**PLANNING COMMISSION SITE PLAN
CONDITIONAL USE PERMIT REVIEW SHEET**

CASE NUMBER: SPC-2010-0061C **PLANNING COMMISSION DATE:** N/A

PROJECT NAME: The New Theatre at Zach

SUBJECT: ZACH New Theatre

① SOUTH ELEVATION
Scale 1/8" = 1'-0"

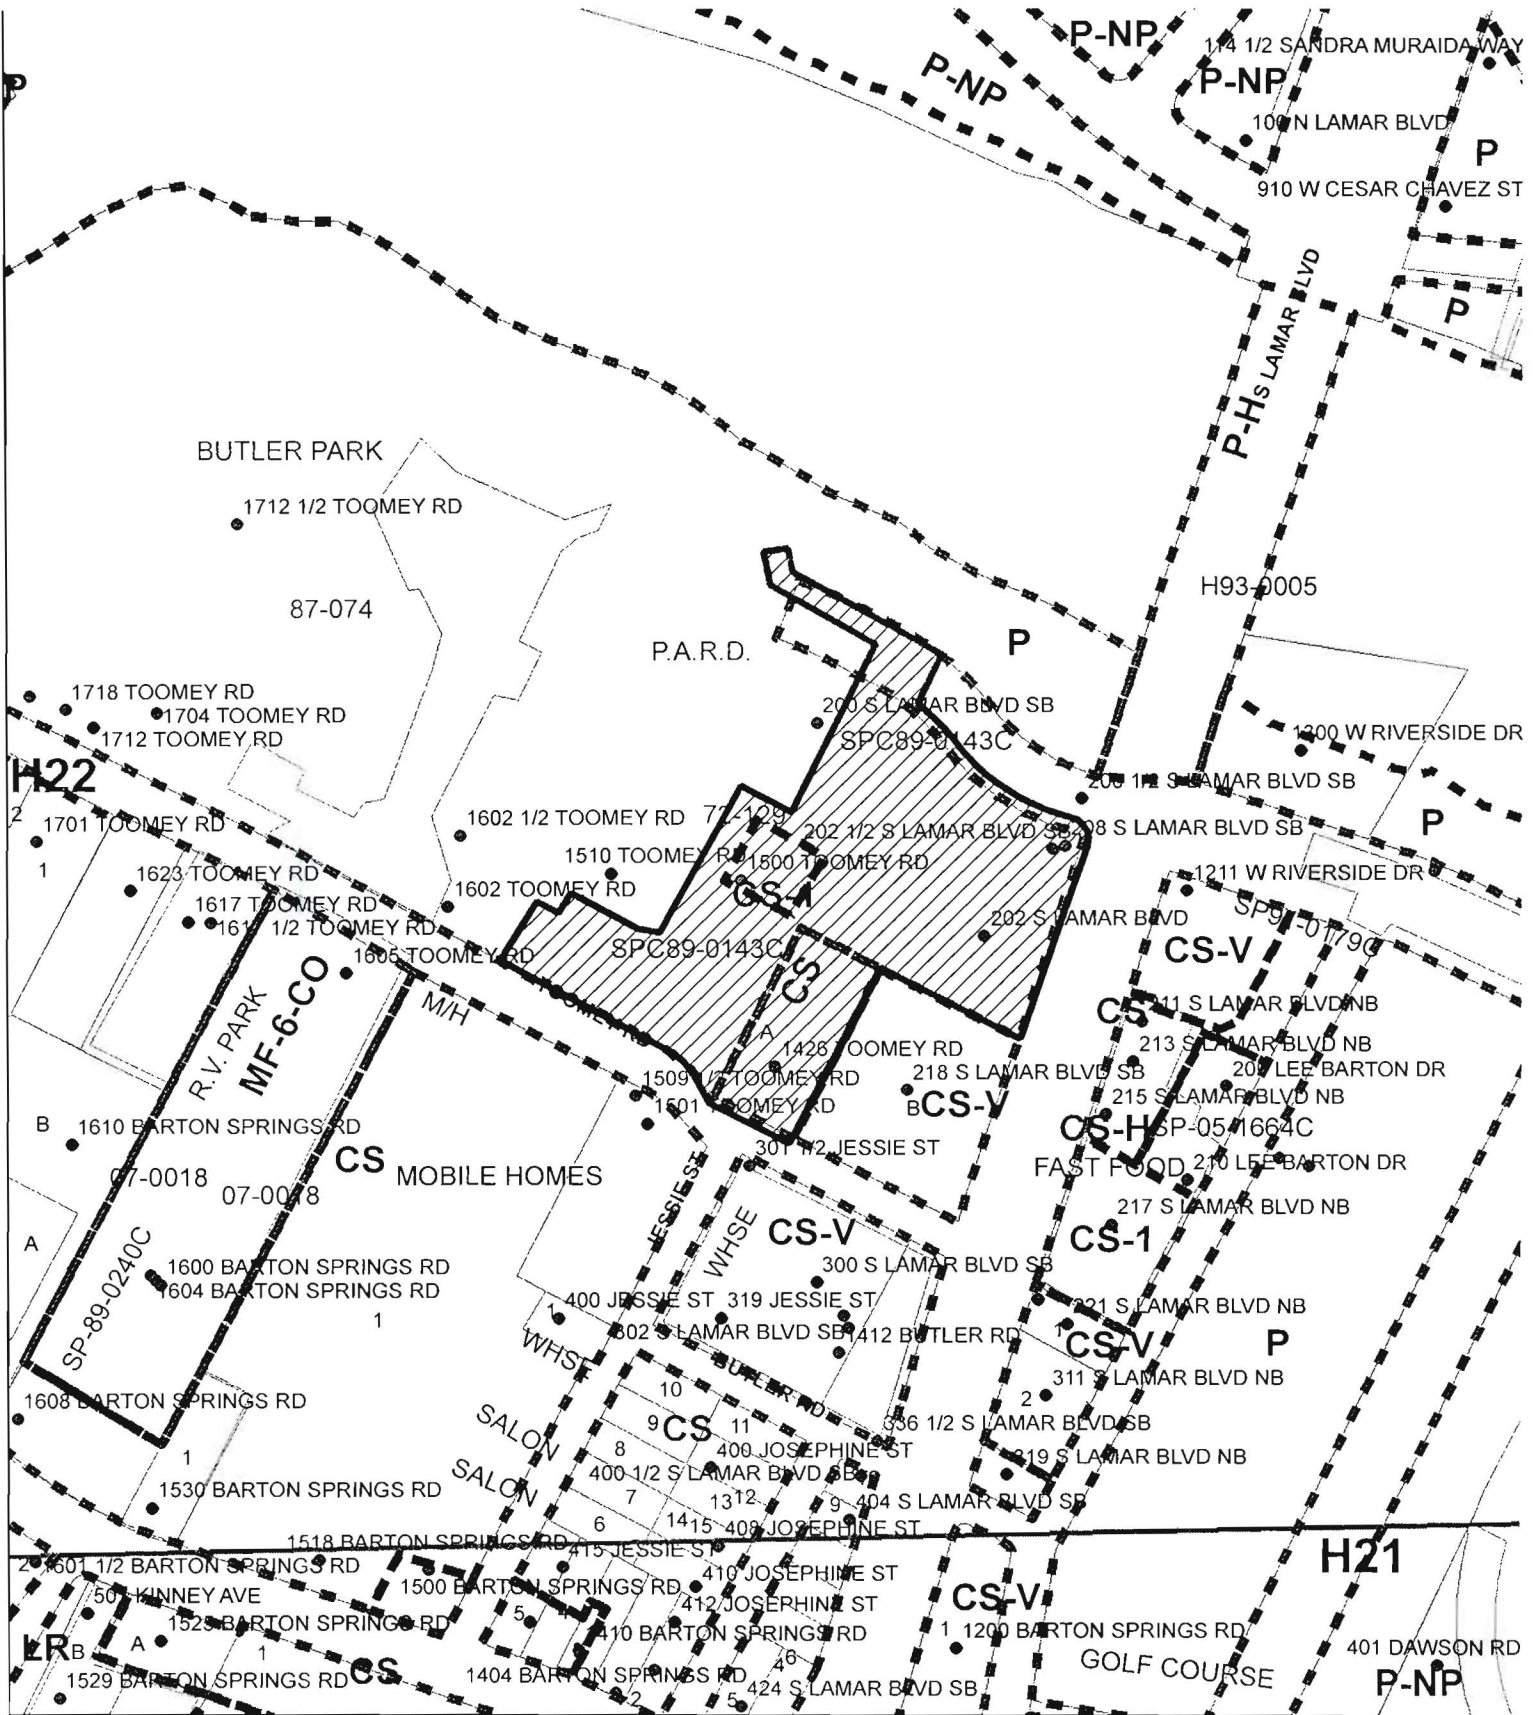
1. Entryways or architectural detailing is required to break the continuity of nontransparent base walls. (3) Except for transparent glass required by this subsection, natural building materials are required for an exterior surface visible from park land adjacent to Town Lake. [LDC Section 25-2-733(E)(2)(3)]
2. For a ground level wall that is visible from park land or a public right of way that adjoins parkland, at least 60 percent of the wall area that is between 2 and 10 feet above grade must be constructed of clear or lightly tinted glass. The glass must allow pedestrians a view of the interior of the building.[LDC Section 25-2-733(E)(1)]

The applicant is requesting a Waterfront Planning and Advisory Board recommendation for approval of this conditional use permit plan, with the variances to the clear or tinted glass requirement as well as the utilization of natural building material requirement for buildings visible to Town Lake. The design meets the intent of the requirement.
